1345 Baseline Road

Architectural Design Report

ZBLA

1345 Baseline Road, Ottawa
Response to Comments - Pre-Consultation Meeting Feedback
Zoning By-Law Amendment Application (PC2025-0177)

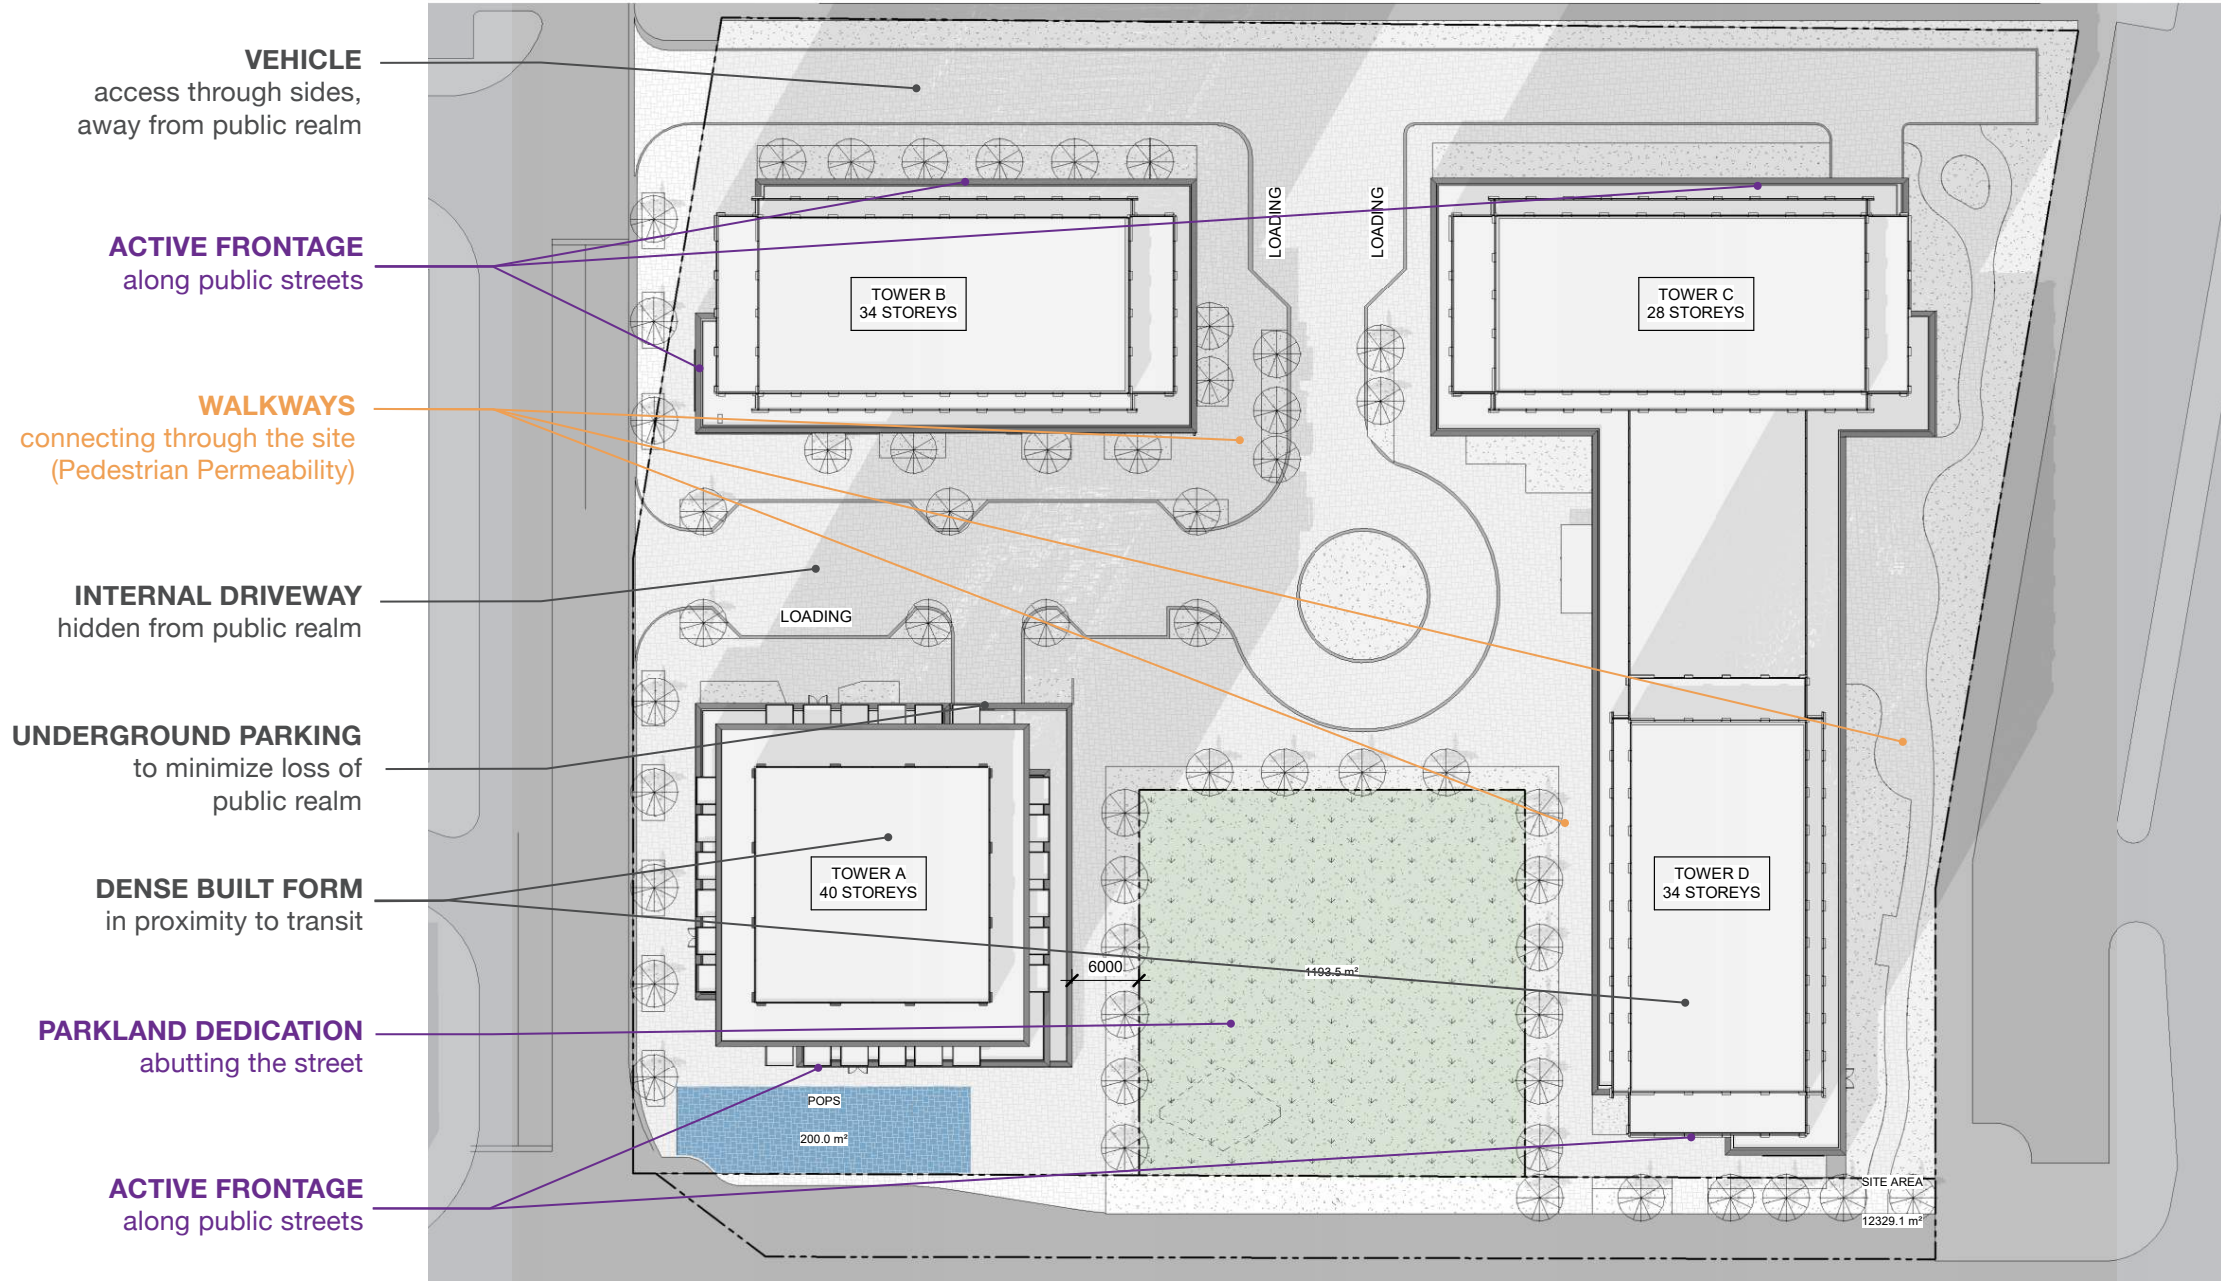
20	The City is in the process of preparing a Secondary Plan which will ensure that the area develops as one large cohesive community with shared roads and amenities, including parks and community services and facilities.	Acknowledged. The applicant team is aware of the Secondary Plan and will remain informed as the process evolves. Appropriate regard will be given to the Secondary Plan throughout.
21	If the development proceeds in advance of the Secondary Planning process, the site will need to be designed in a manner that supports broader connections into the larger community.	Acknowledged. The site is being design to support connections into the community, as showcased by the public road, internal circulation network, and site pedestrian permeability.
22	UD Staff think that there should be at least one public road preferably east-west that provides connections into the broader community with the potential for future expansion as the area continues to intensify:	A public road, as shown in the image below, has been incorporated into the site design.
